ADDENDUM | 03
Mary C. Howse Elementary School
641 Boot Road, West Chester, PA 19380
BHA Job No. 22-114

DATE OF ISSUANCE: December 1, 2023

The following information shall become part of the Contract Documents for the above referenced project.

1 FOUNDATION PLAN - AREA 'E' - RAMPS
 SSK-1 SCALE: 1/16" = 1'-0"

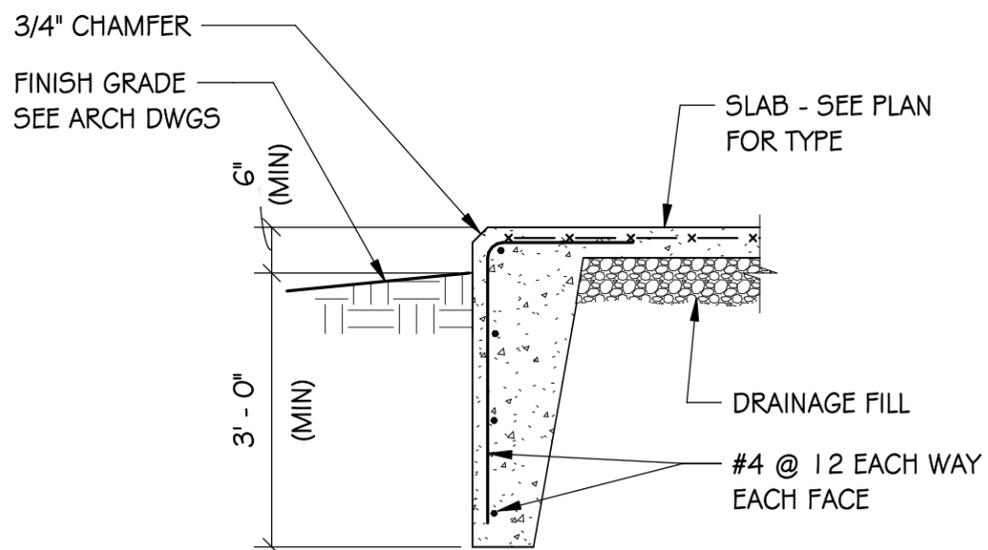
Drawing S1.0A – FOUNDATION PLAN – AREA ‘A’
Add concrete ramp from proposed addition; see SSK-1.

Drawing S1.0E – FOUNDATION PLAN – AREA ‘E’
Add concrete ramps from proposed addition; see SSK-1.

Drawing S3.01 – FOUNDATION DETAILS
Add concrete ramp detail; see SSK-1.

① **ACCESS CONTROL DIAGRAM**
NO SCALE

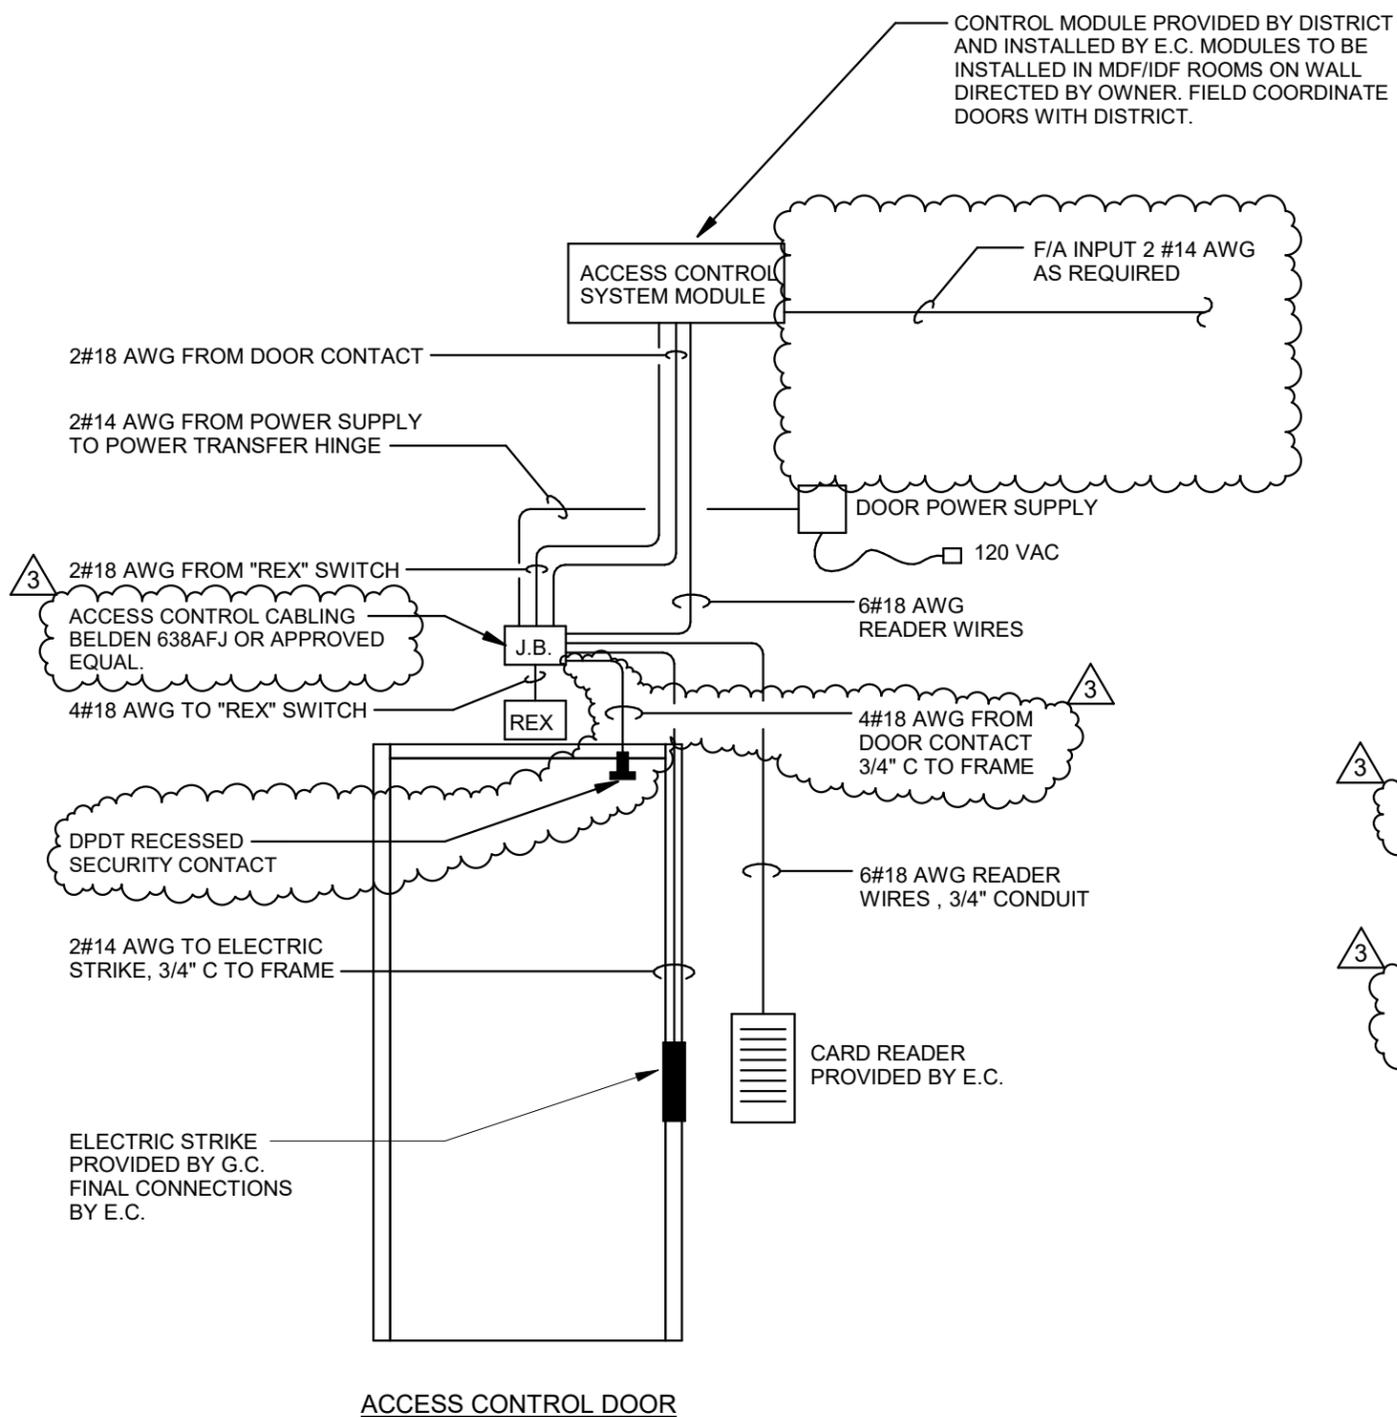
Revise detail #9 ACCESS CONTROL DIAGRAM per attached sketch SKE-01.
